WORK ORDER NON-CONFORMANCE / UPDATE

Item Name: Eyelet Bracket Assembly

650.9201

EYELET BRACKET ASSY

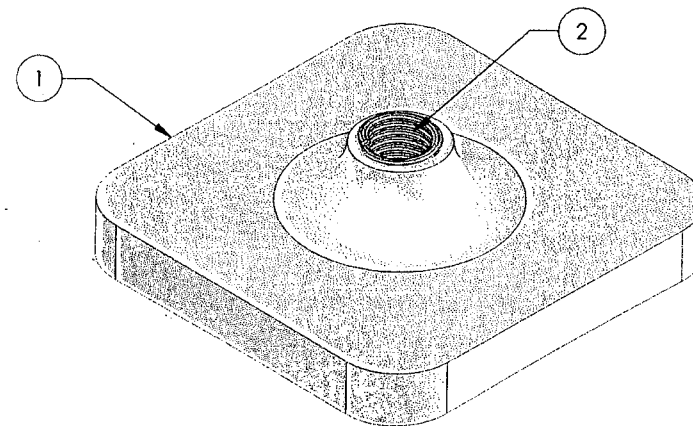
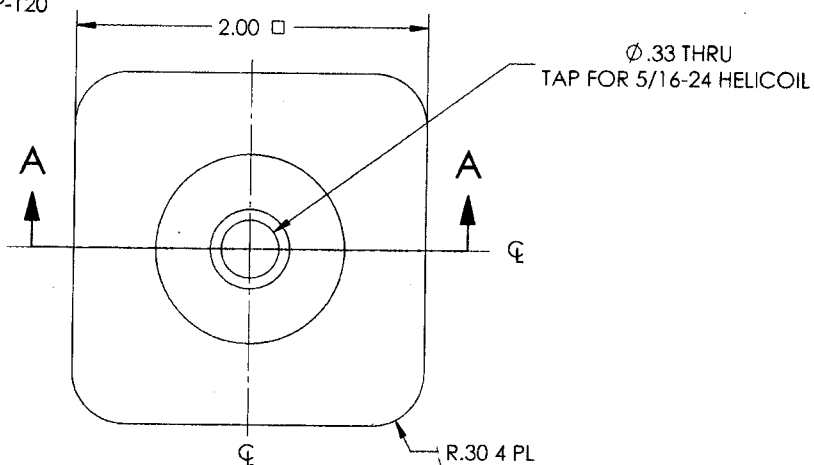
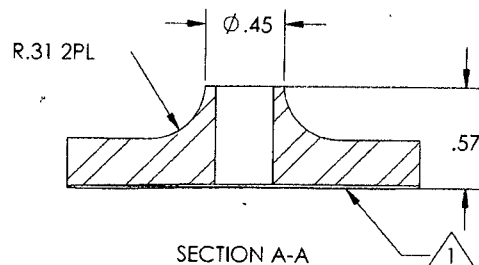
I would get a shorter one, there is nothing holding that last "coil" in place so the pitch of the thread may be off making it harder to screw in the bolt.

I talked with Joe, he mocked up this assy based off of the EC135 CCK design I believe. I don't see why the helicoil should stick out of the top of the base bracket. We probably want to go ahead and get a smaller one unless you don't see anything wrong with having it stick out a little bit.

We have been assembling the new 650.9201 with Helicoils and noticed that there is one coil sticking out once fully inserted, as the overall height of the part is .57" and the insert called up is .625" long. But in the ISO view on the dwg it shows the insert sticking out(see below), I don't know if this was intended or should we revise the helical insert to a shorter one?

(MS21209 F5-15) → m 133134

I'm going to revise the drawing... (again, *sigh*). The new helical will be about .469 in length. That is the next shorter size. MS21209F5-15. Do you see any issues with the helical being too short?
